**NOTICE TO BIDDERS
ADDENDUM #002**

TO THE BID FOR: B024-63 Gallery 53 Elevator Replacement & Egress Upgrades

Gallery 53
Elevator Replacement and Egress Upgrades
Bidding RFI Responses
June 25, 2024

MECH. ELEC.
BASEMENT, 1ST & 2ND PLANS

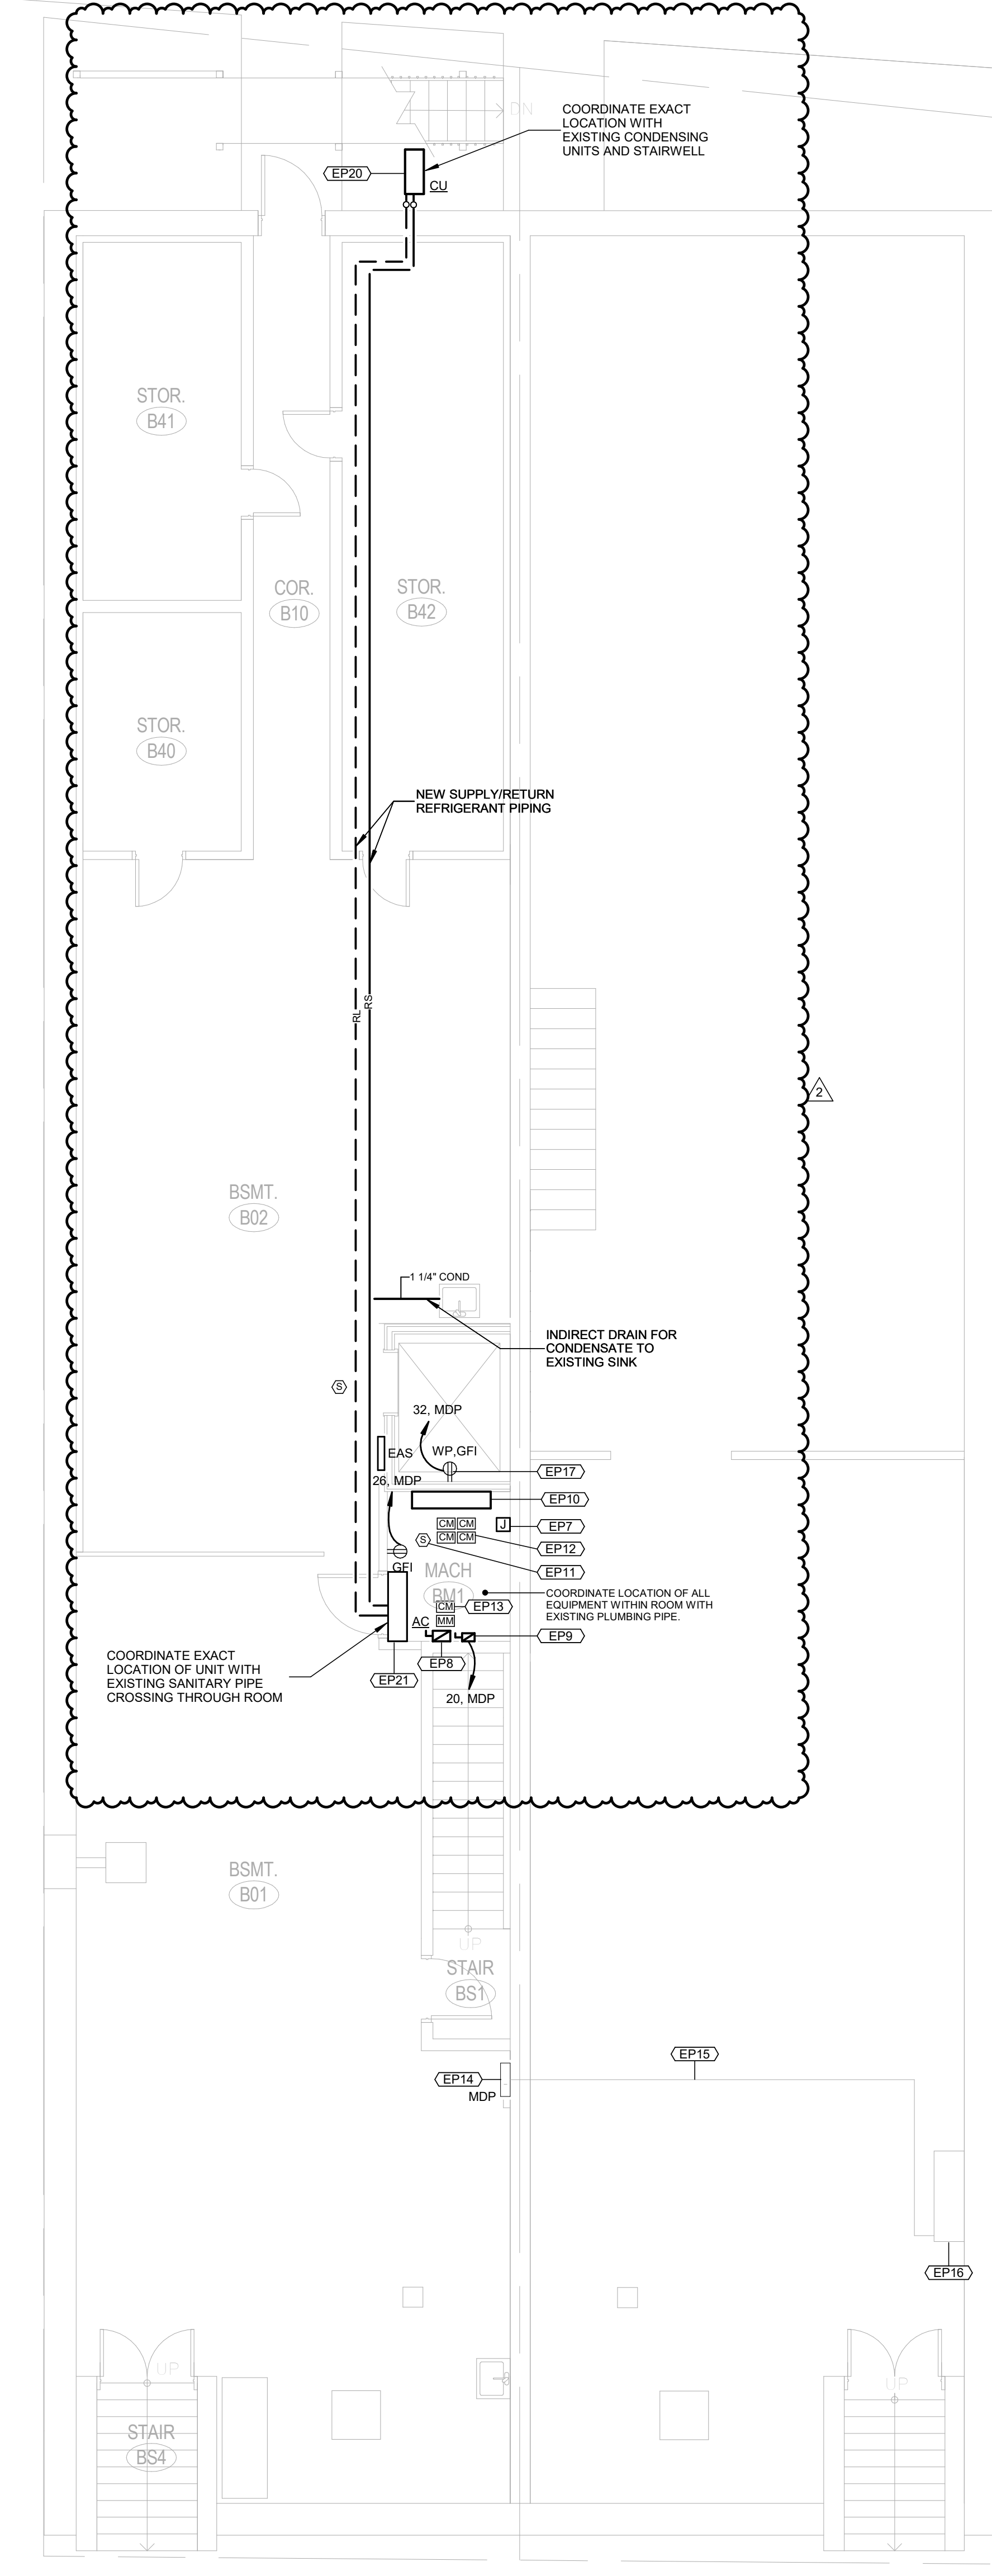
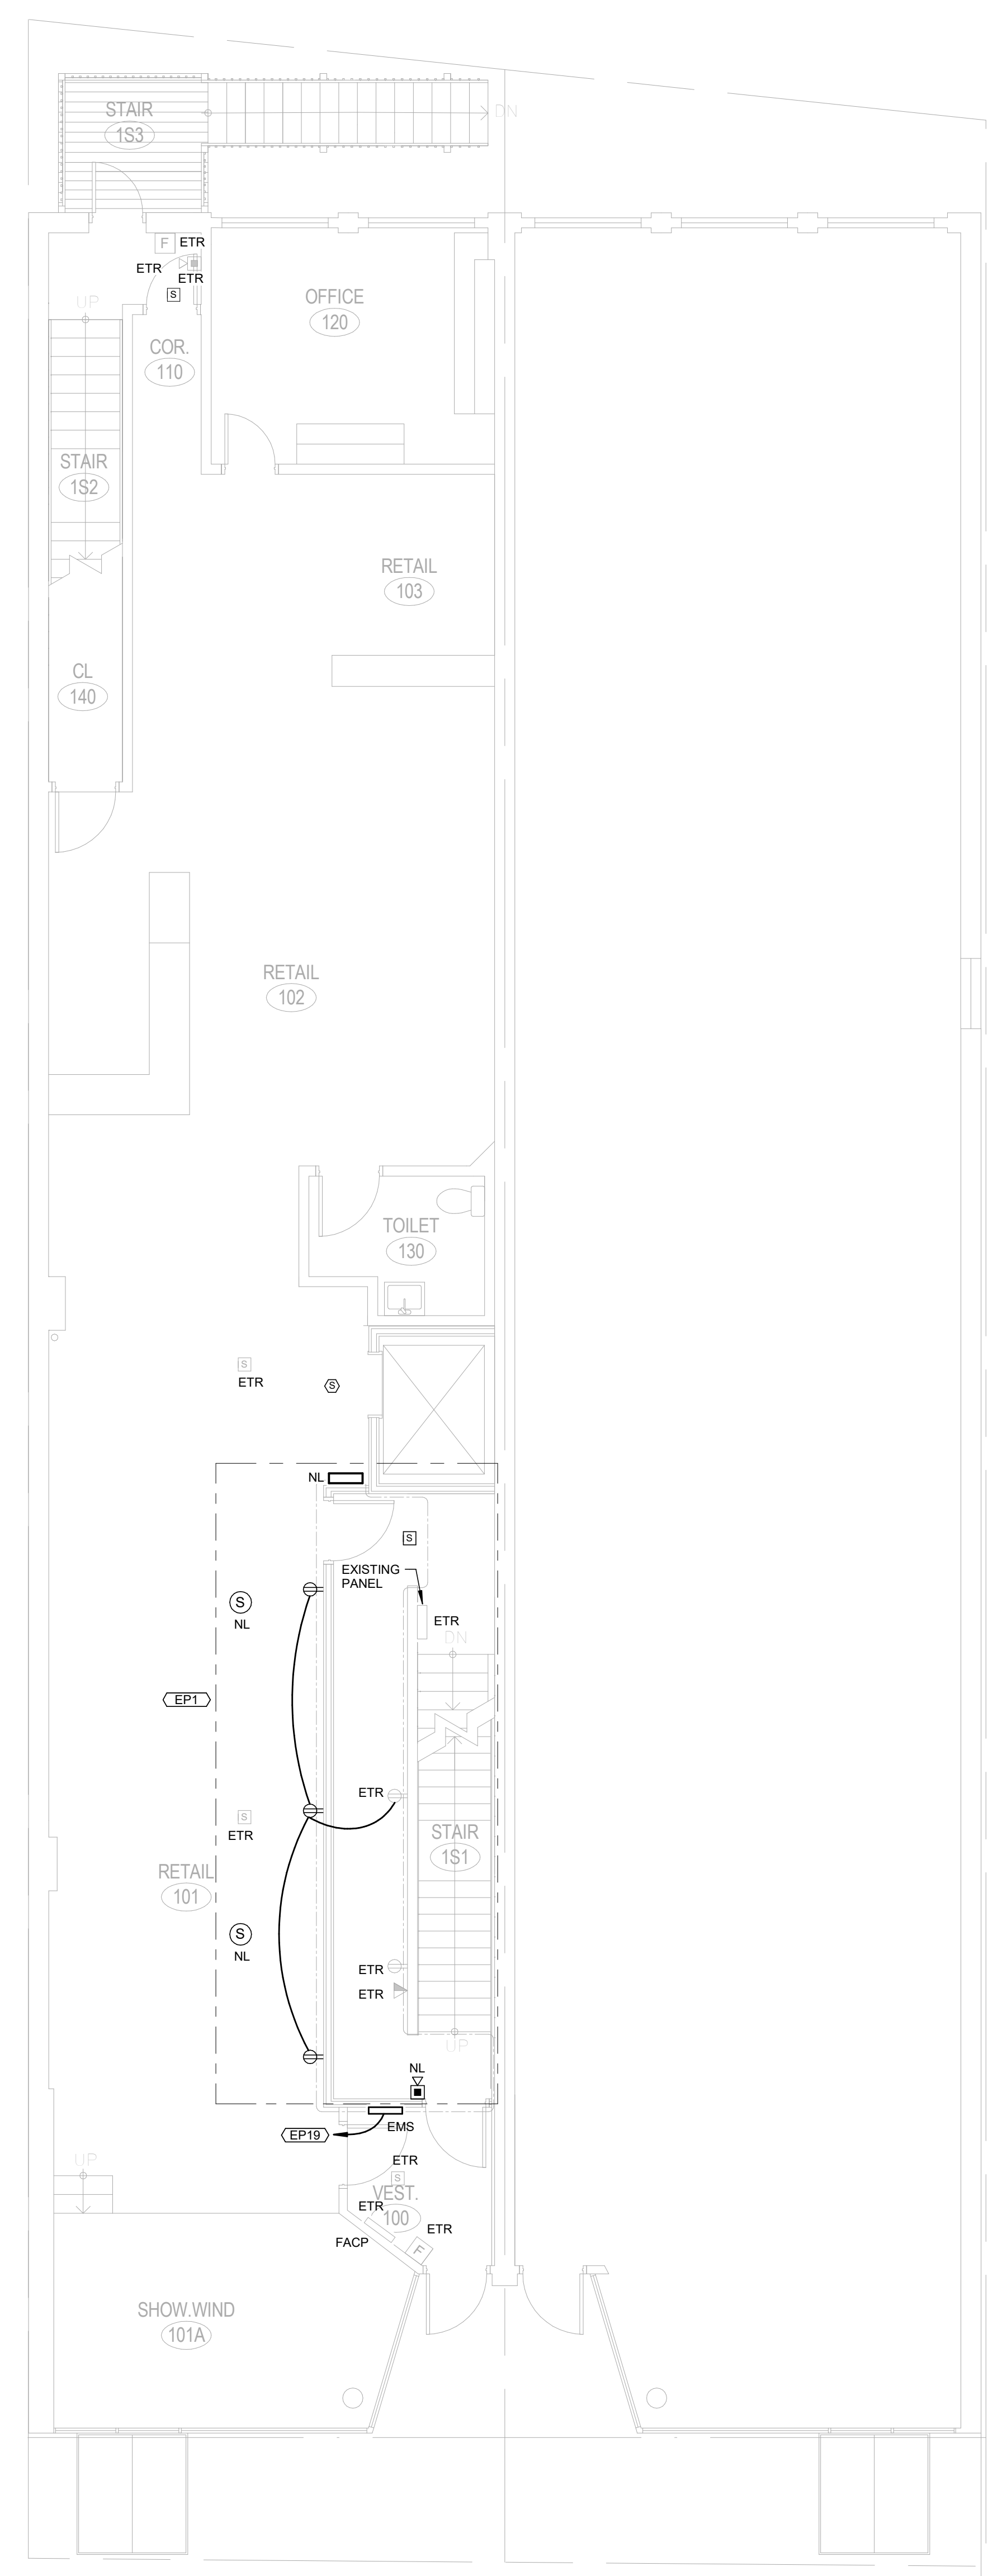
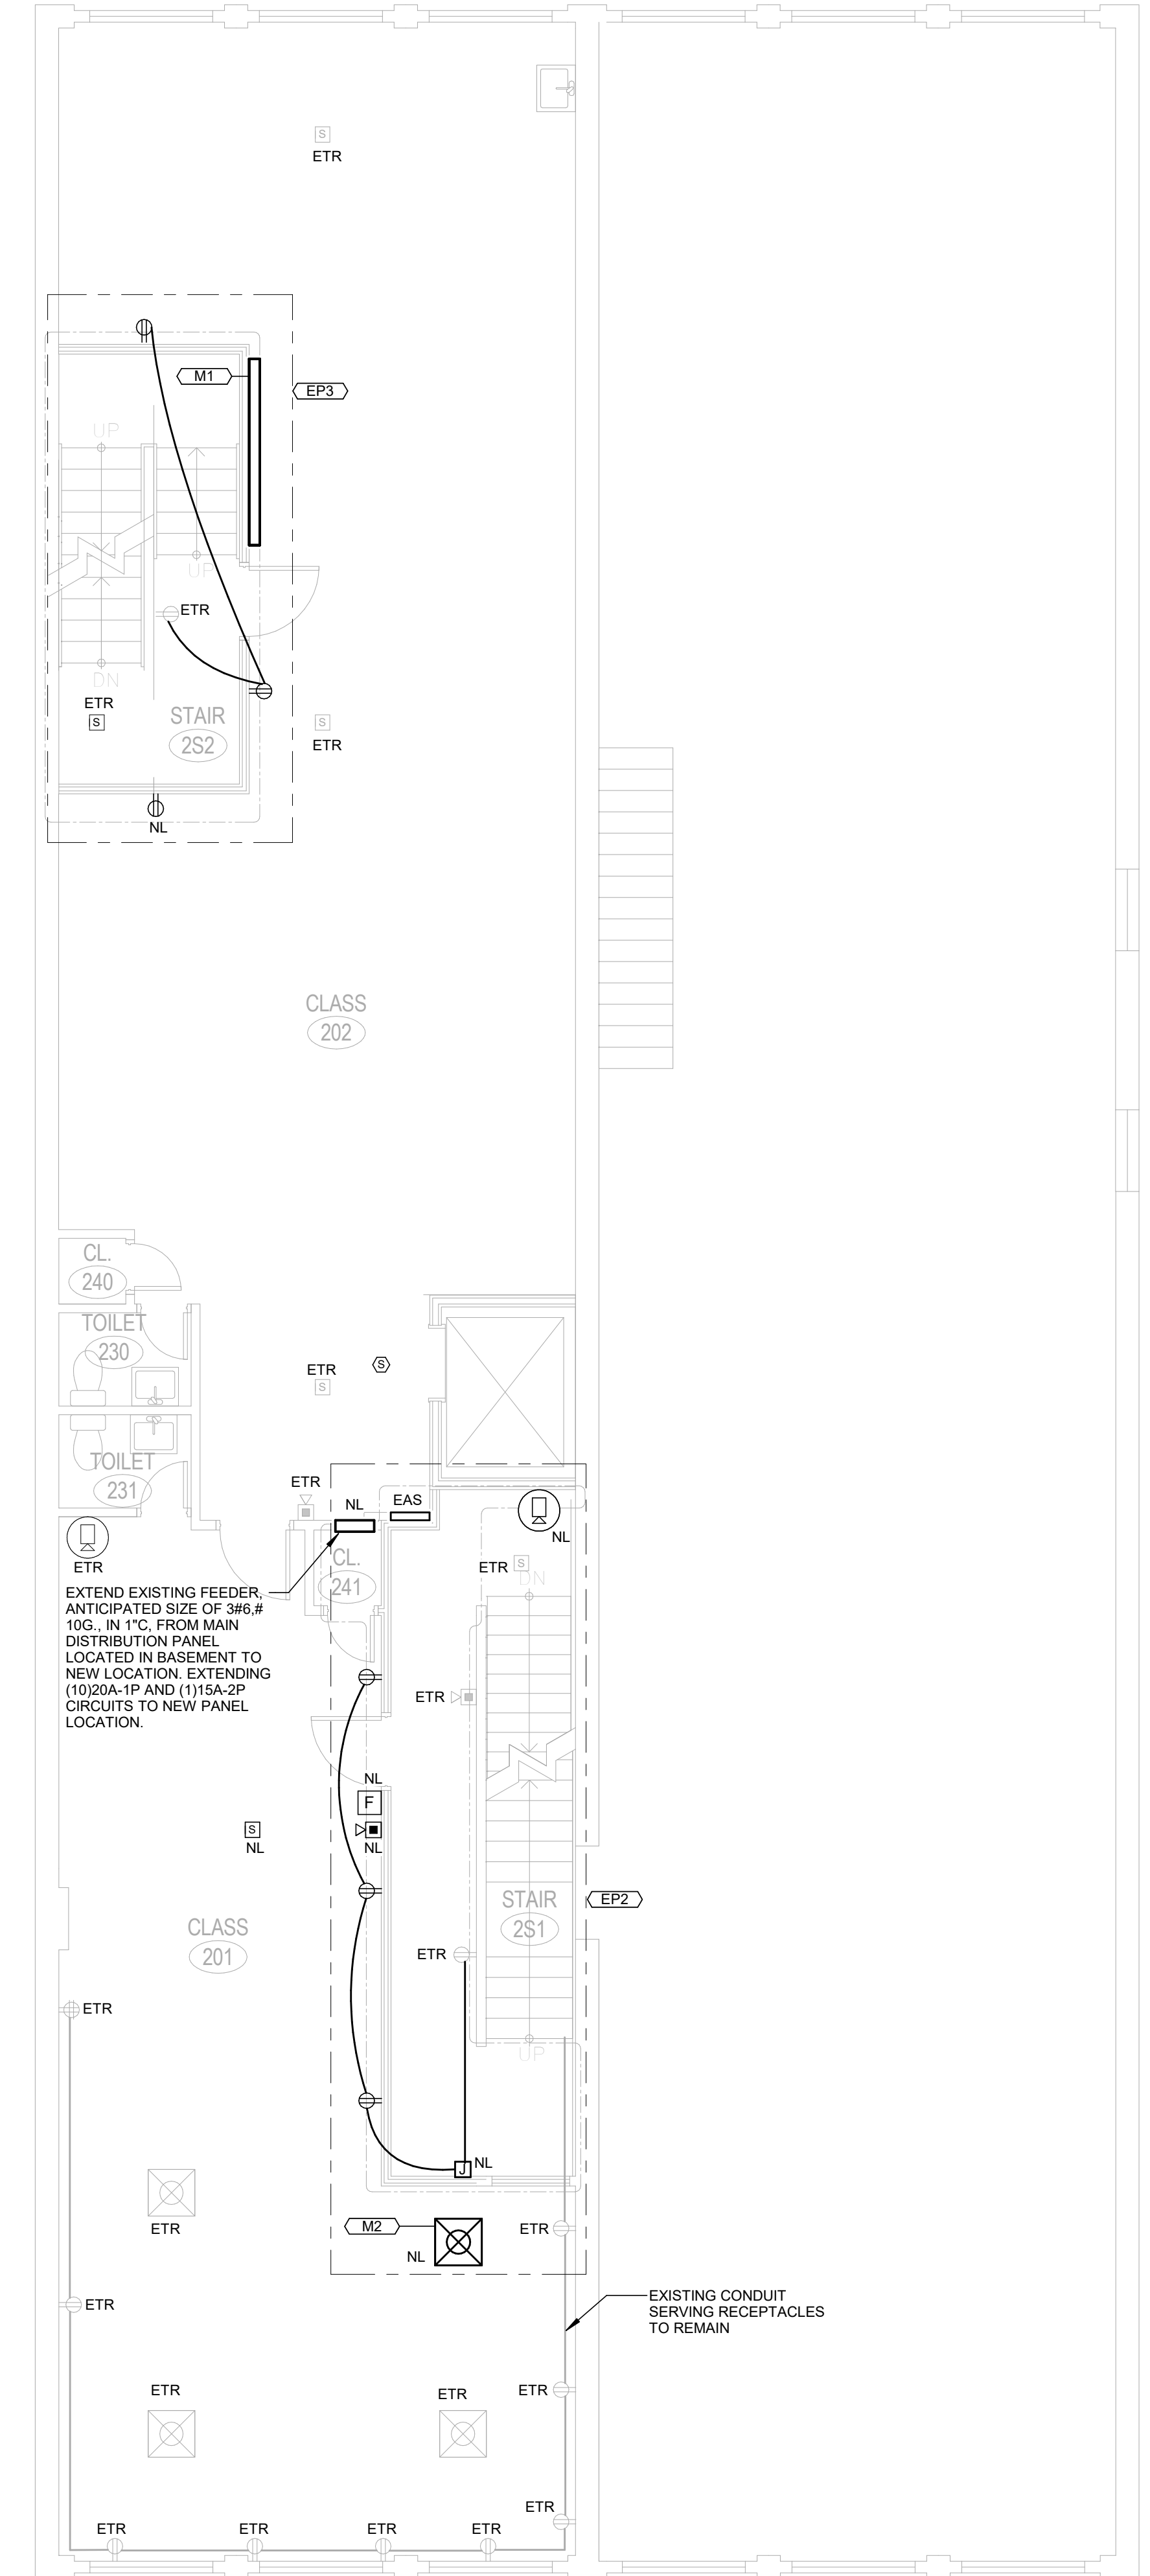
7. A. Is a heating/cooling system required for the mechanical room?

See Revision #2 Machine Room Cooling.

BID DOCUMENTS		
COPYRIGHT 2023		
NO.	DATE	REVISIONS
2	6/25/2024	MACHINE ROOM COOLING
